Memorandum

From: Robert Ellison

Re:

Construction of the sludge lagoons commenced on 28 June 2010. Initial activities included clearing and grubbing and sludge removal. Up to the 1st payment certificate – there were minor problems to do with smoke, a diversion channel, excessive clearing, etc. Minor issues typical of a construction project which were solved as they arose. Sludge stockpiling posed problems of storage – with excess volumes – that were not identified in design. This problem was resolved using a 25 tonne excavator to increase the height of the pile – as an extra to the contract. Associated problems with excess sludge necessitated extending the area of the storage with additional clearing – again at an additional cost.

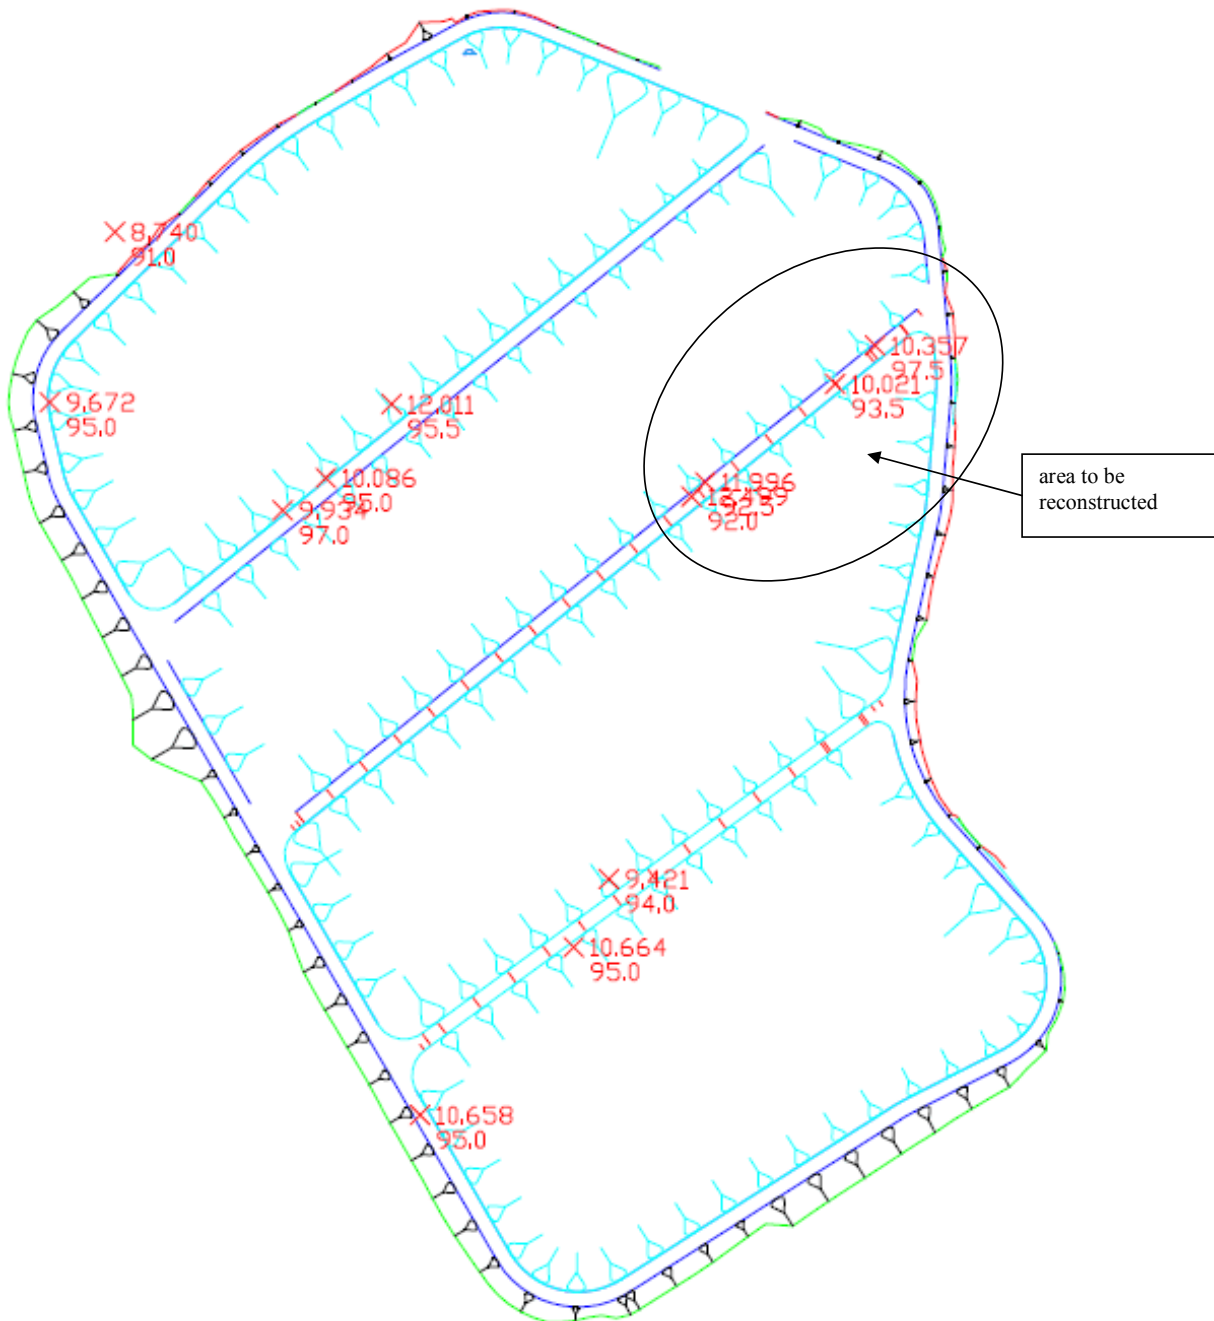
GHD were concerned with moisture content in relation to permeability – and suggested that as most tests were outside of specified moisture content ranges this was a problem we had not considered. I think this is an over reaction. A typical soil with 10% water content (by weight) has 25% voids. The same material with the same dry density (tonnes/m³) with 5% moisture has 25% voids – 12.5% water and 12.5% air. It is both the voids (total for air and water) and soil structure (flocculation and dispersal) that determine permeability. Soil moisture (according to AS3798) is specified as a guide to achieving compaction with minimal effort. I think GHD have very much the wrong end of the stick on this – but it is something we may now need to deal with. As such – we have asked Cardno Bowler to address this issue and provide their take on this issue.

The results for field moisture results that are out of specification are shown in attachment 2. This includes most of the testing across most of the walls.

Attachment 1: Locations and levels of compaction results that are less than 98% standard

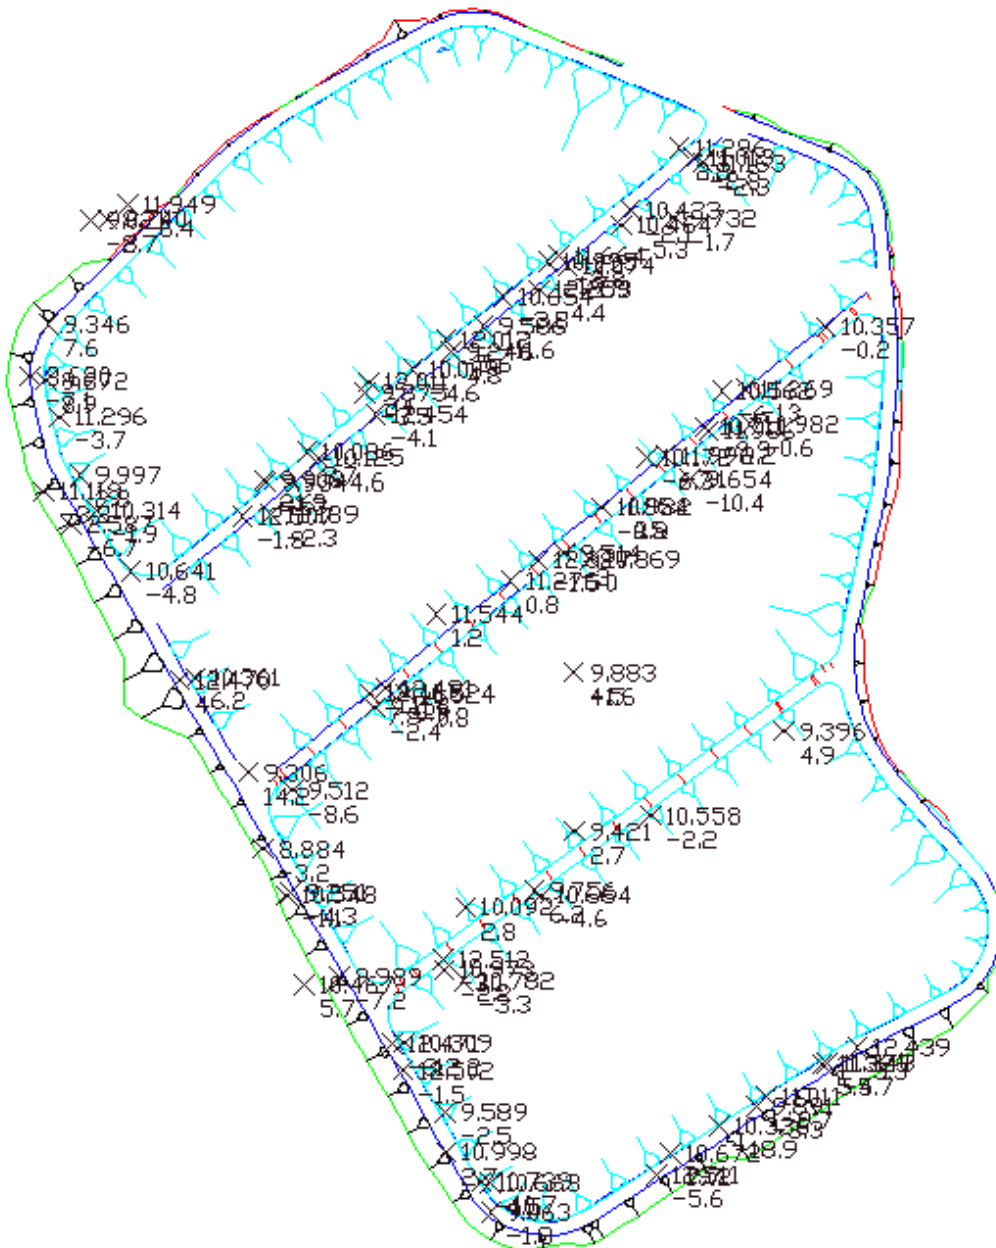
information on compaction and moisture content – as analysed by GHD - is included in an enclosed spreadsheet. Compaction results were sorted by pass or fail in the spreadsheet and imported into Civil3D. These were then manually sorted for repeat tests at or near the same location and level. The remainder showing fails that had not been retested is shown in Attachment 1.

In general the results show 2 spots at 95% compaction in the outer wall, one anomalous result outside the wall and several more in internal walls. Although I might add that 3 of the lowest results previously supplied have dropped off the list. The results for compaction suggest minimal risk – although I am reluctant to make a call until it is certain that all results have been supplied. To this end we have asked Cardno Bowler – as the geotechnical testing authority for Camco - for a Level 1 inspection report to AS3798 and will review this information when available. We have also suggested that Cardno Bowler specifically review moisture content and the implications of this and as well to suggest ways forward in relation to soft spots in the wall.

We are intending to review and compare options to arrive at the best way forward. My inclination is to reconstruct in the area shown in Attachment 1.
